1st Further Information

**Proposed Temporary Warehouse (excl. D.G.G.) with Ancillary Facilities and
Associated Filling of Land for a Period of 3 Years in "Agriculture" Zone,
Various Lots in D.D. 89 and Adjoining Government Land, Man Kam To, New Territories**

(S.16 Planning Application No. A/NE-FTA/280)

Preliminary Geotechnical Assessment Report

GENERAL LAYOUT PLAN

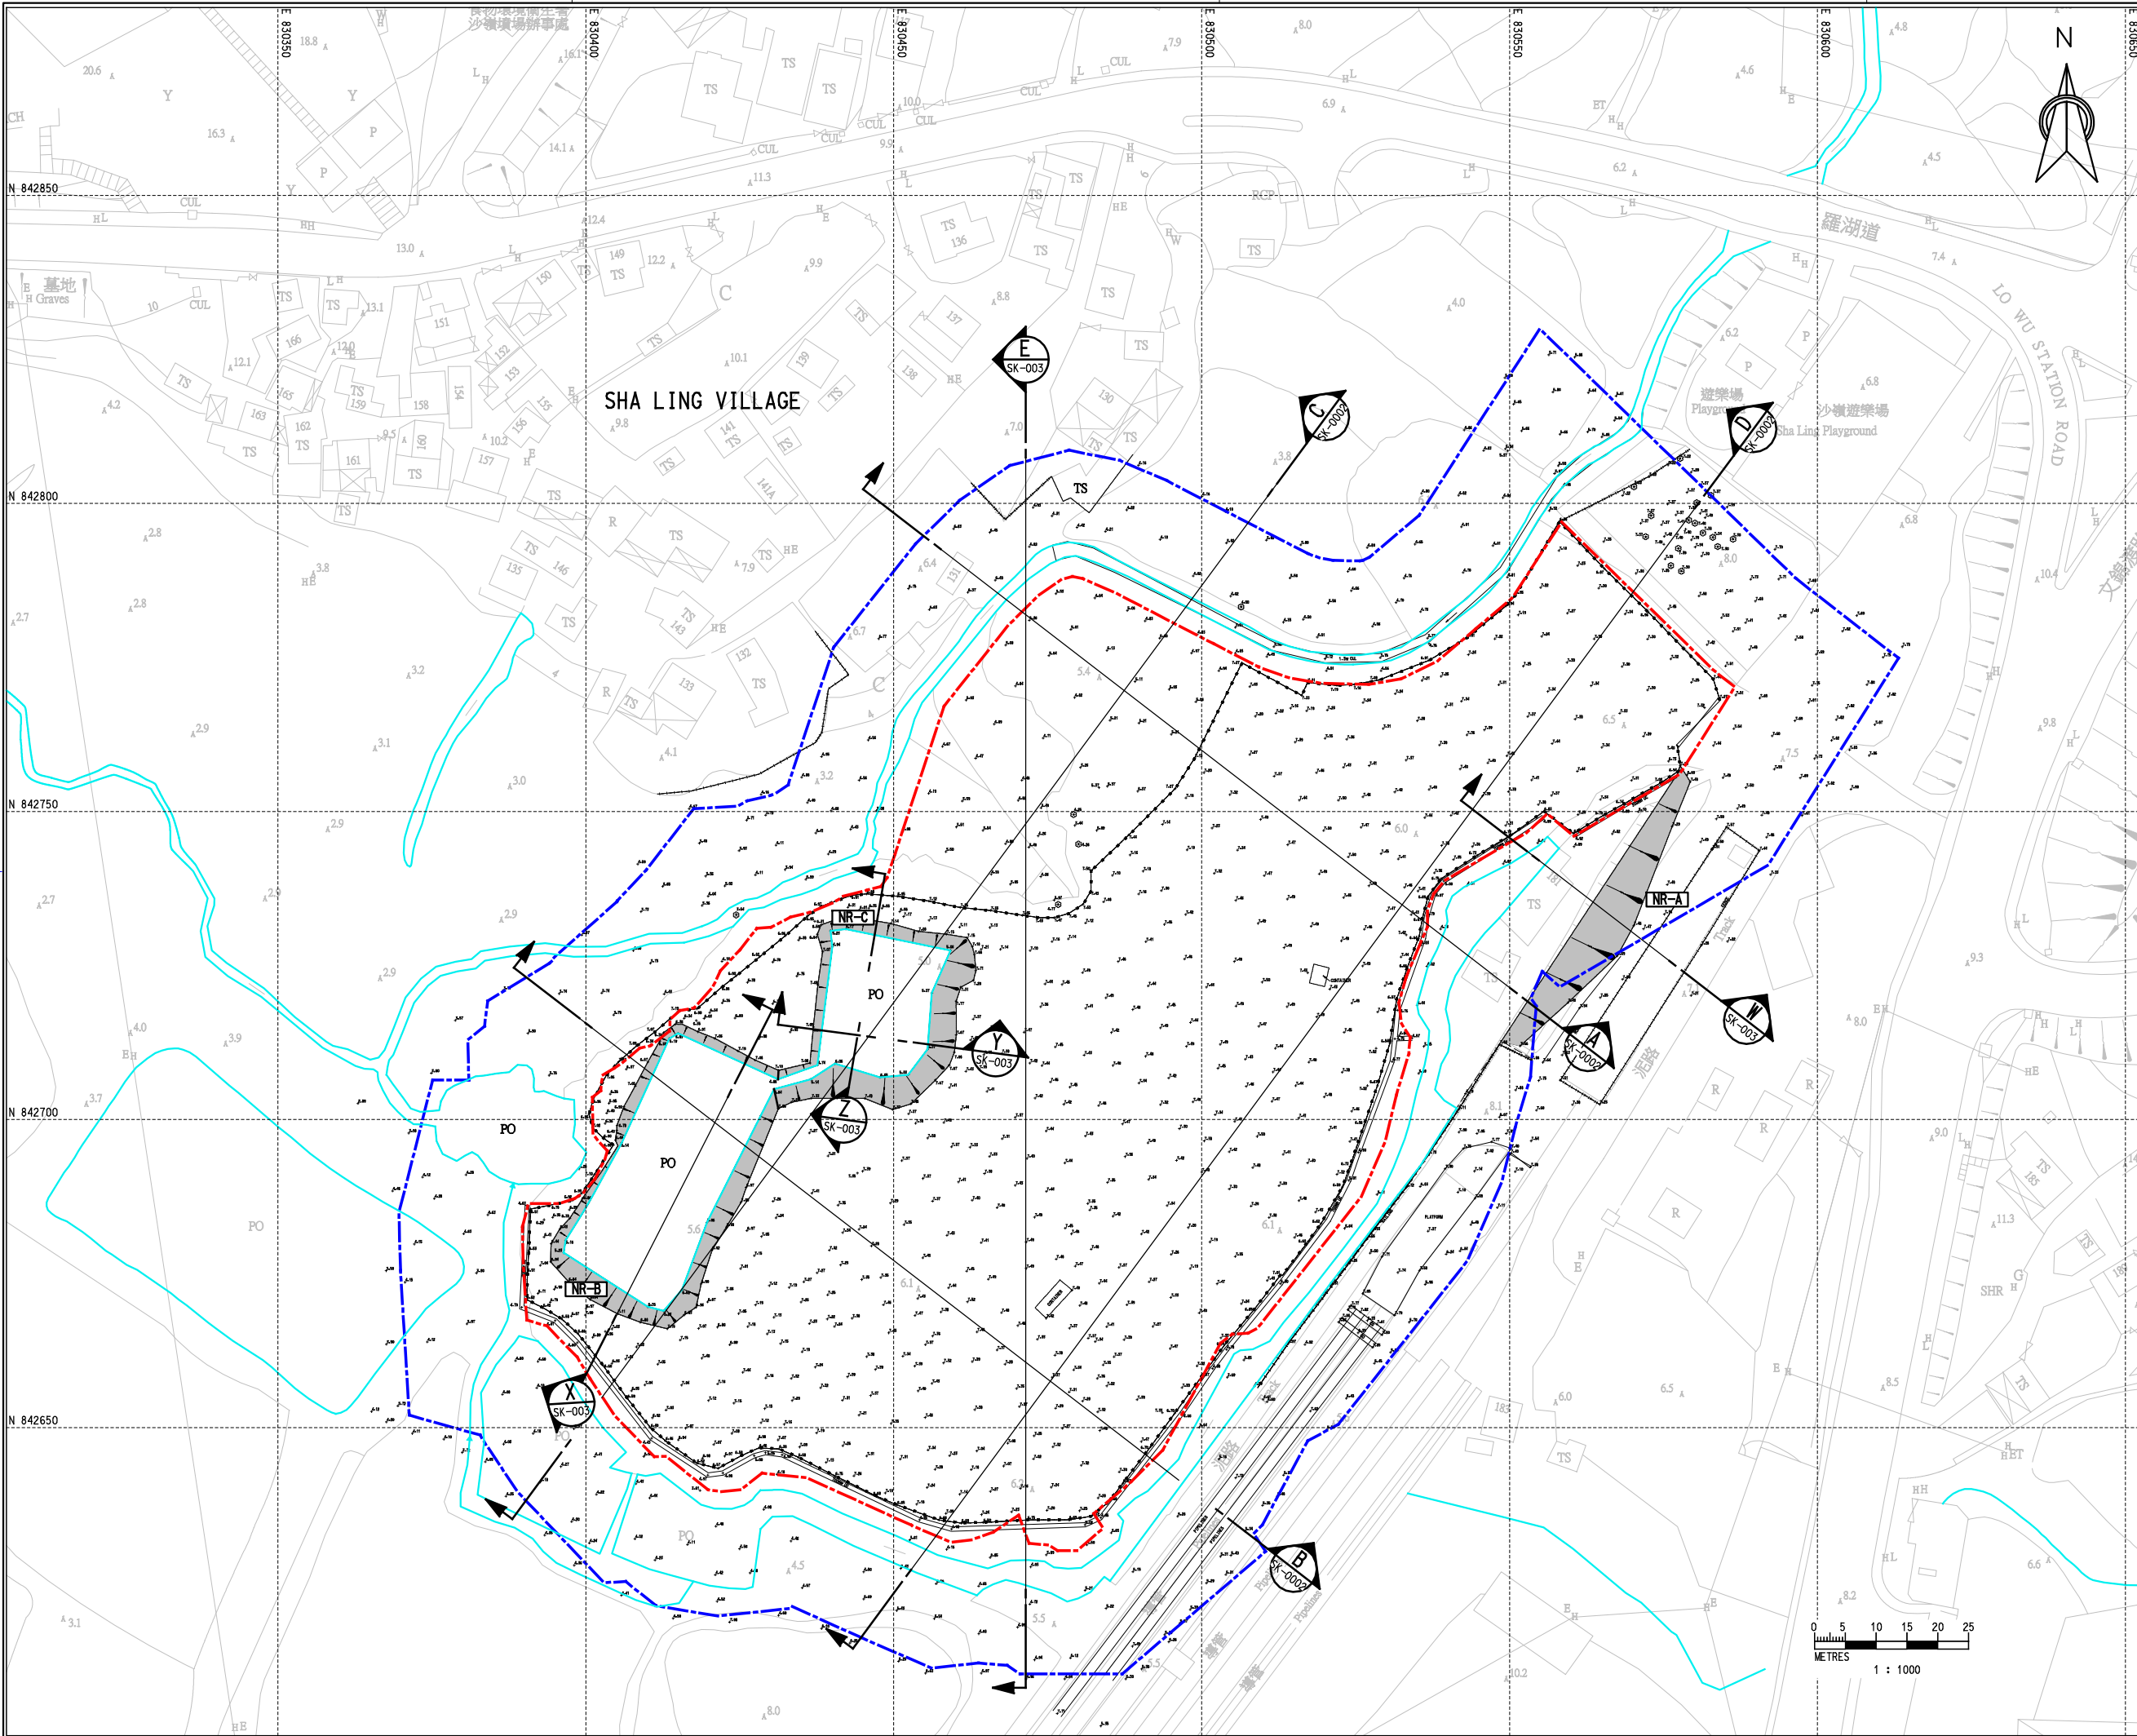
(b)	As the subject planning application would affect or be affected by the above-mentioned unauthorised works, the applicant shall submit a detailed topographic survey including plans and at least four cross sections (covering at least 20 m extending away from the Site boundary with particular emphasis on showing the interface with Sha Ling Village to the northwest of the Site). Existing unregistered and registered man-made geotechnical features (i.e. slopes/retaining walls) should be identified according to the survey results. If the geotechnical features are present, the applicant should further incorporate a preliminary geotechnical assessment of these identified geotechnical features, which might affect or be affected by the proposed development.

2. As the subject planning application would affect or be affected by the above-mentioned unauthorised works, the applicant shall submit a detailed topographic survey including plans and at least four cross sections (covering at least 20m extending away from the Site boundary with particular emphasis on showing the interface with Sha Ling Village to the northwest of the Site). Existing unregistered and registered man-made geotechnical features (i.e. slopes/retaining walls) should be identified according to the survey results. If the geotechnical features are present, the applicant should further incorporate a preliminary geotechnical assessment of these identified geotechnical features, which might affect or be affected by the proposed development.

- 2.1.3 Topography survey was conducted and the findings are shown in **Drawing No. Y1066/GL/001**.

- 2.3.1 According to Slope Information System (SIS) of Geotechnical Engineering Office (GEO), of Civil Engineering and Development Department, no registered man-made geotechnical feature is located within the site boundary and within 20m beyond the site boundary (**Figure 2**).
- 2.3.2 A total number of 3 man-made slopes are identified within the site boundary and within 20m beyond the site boundary, which are shown in **Drawing No. Y1066/GL/001** and summarized in table below:-

Swept Path Analyses
(Container Vehicle)

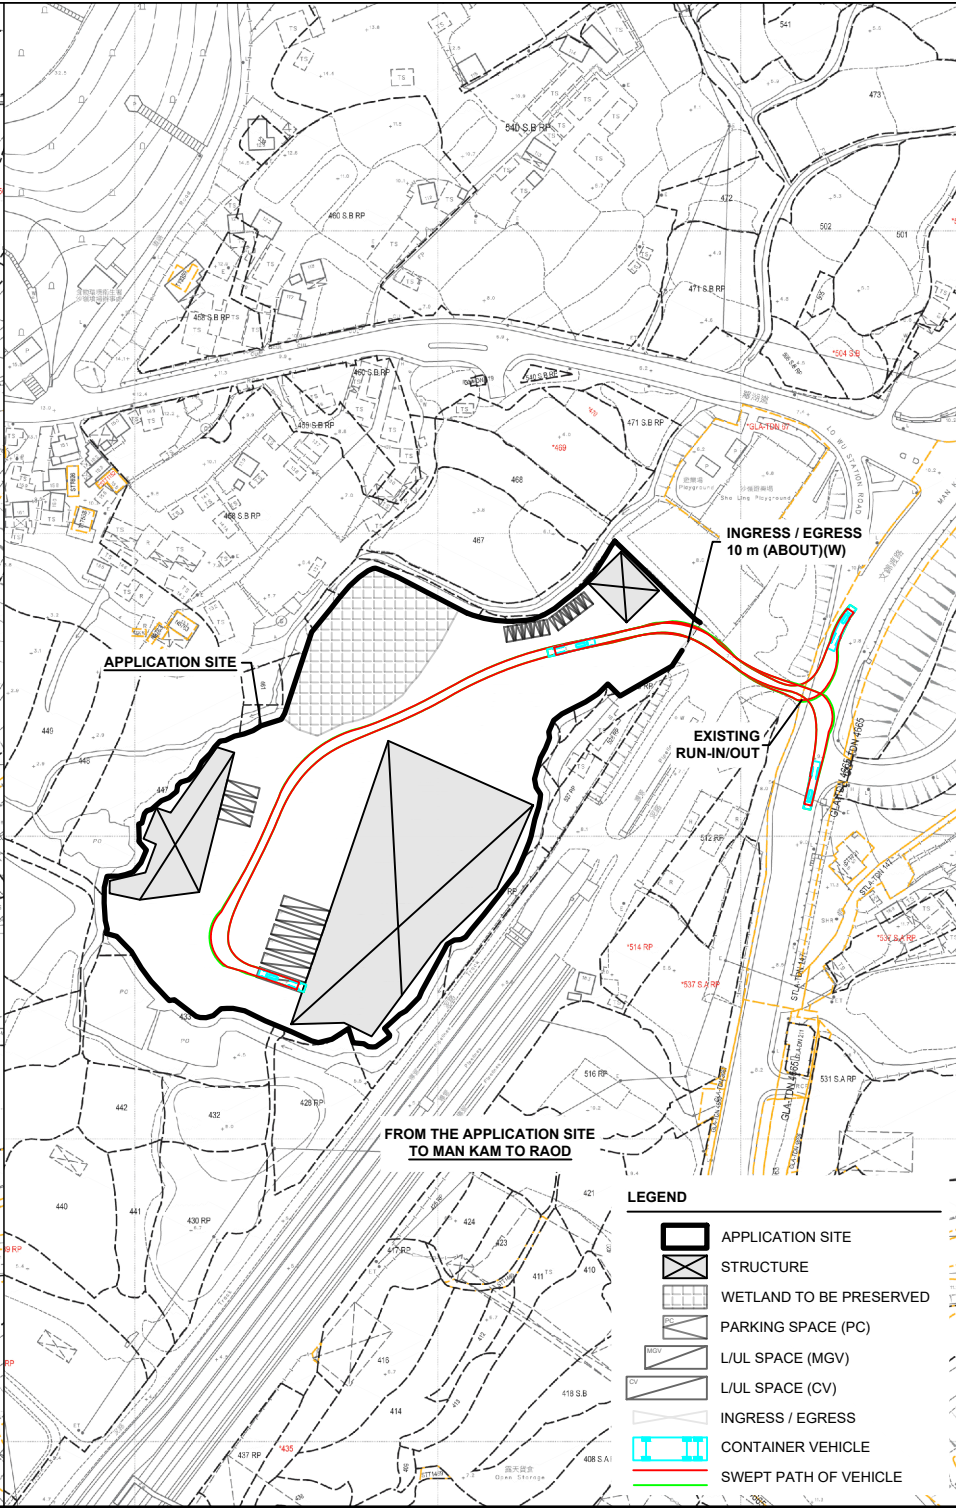
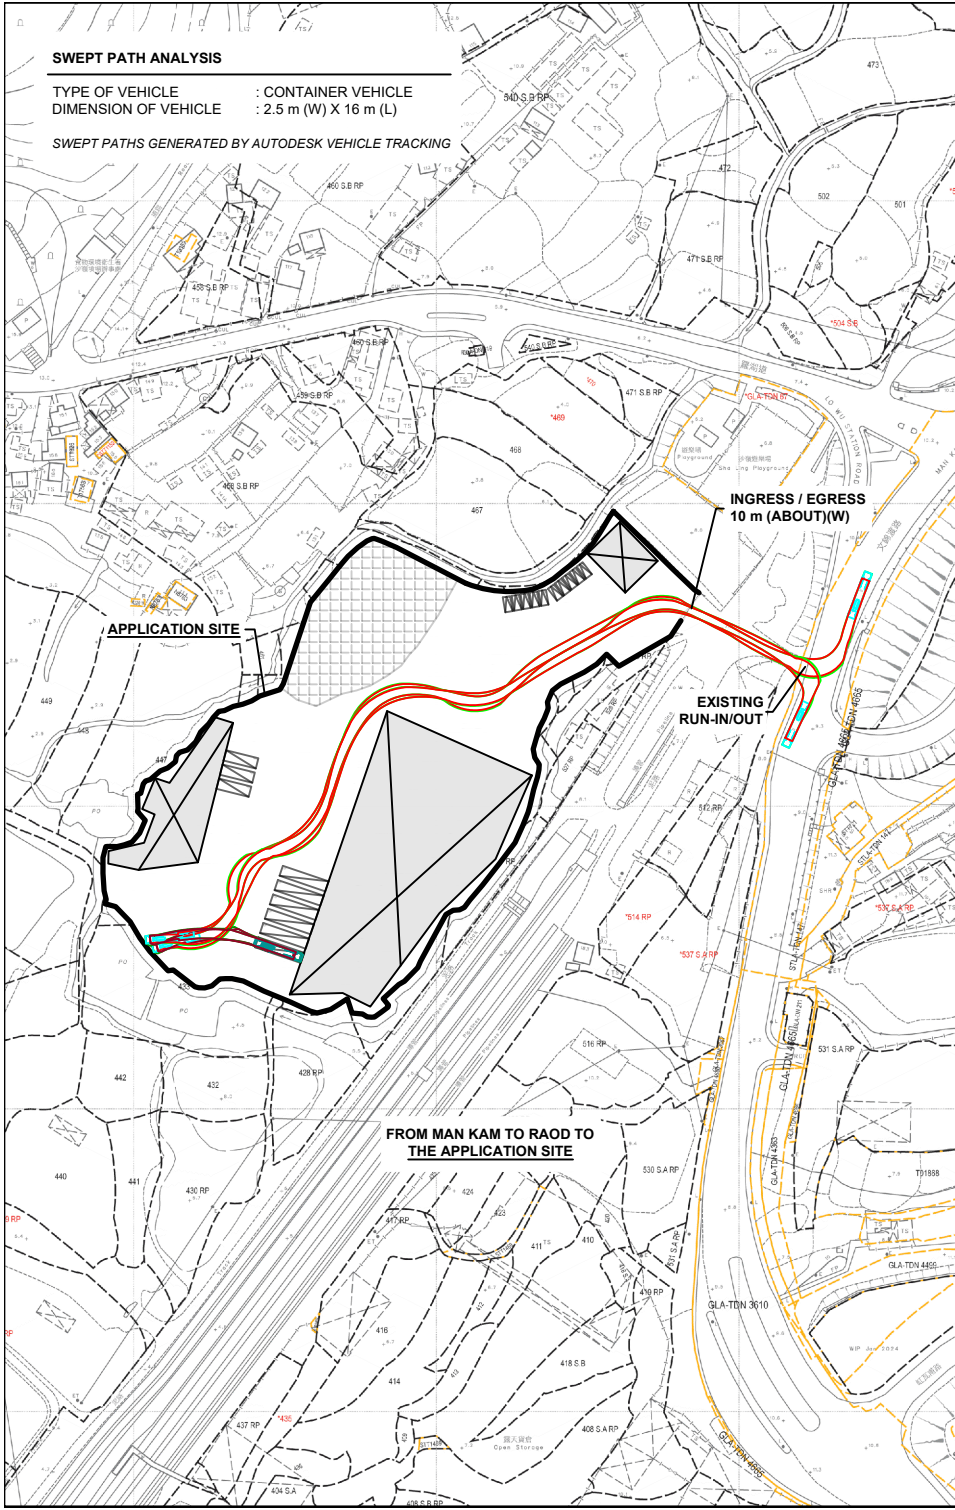
(b) The applicant should indicate the run-in/out to Man Kam To Road in the maneuvering plans to demonstrate the satisfactory maneuvering of the container vehicles including left-in, left-out, right-in and right-out movements between Man Kam To Road and the applicant site.	The swept path analyses have demonstrated the smooth maneuvering of container vehicles between Man Kam To Road and the Site (Annex 2).
